**CITY OF TEMPE
REQUEST FOR COUNCIL ACTION**

**Council Meeting Date: 12/03/2015
Agenda Item: 6C5**

ACTION: Hold the second and final public hearing to adopt an ordinance for an Amended Planned Area Development and Development Plan Review consisting of a new parking structure for OPERATIONS CENTER, located at 1305 West 23rd Street. The applicant is Mesfin Samuel of The Samuel Group. (Ordinance No. O2015.55)

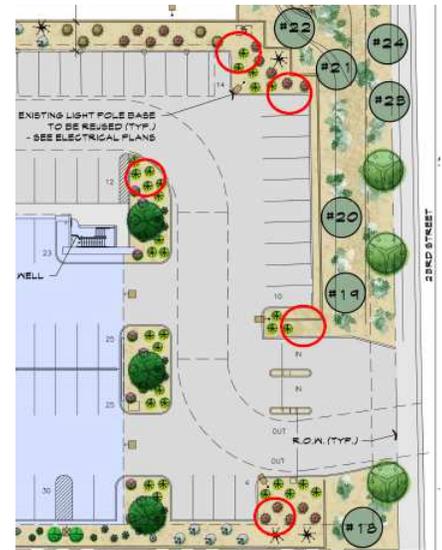
- Add code required landscape island trees for surface parking rows as indicated in the plan to the right:
- **SIGNS:** Separate Development Plan Review process is required for signs in accordance with requirements of ZDC Part 4 Chapter 9 (Signs). Obtain sign permit for identification signs. Directional signs (if proposed) may not require a sign permit. Directional signs are subject to review by planning staff during plan check process.
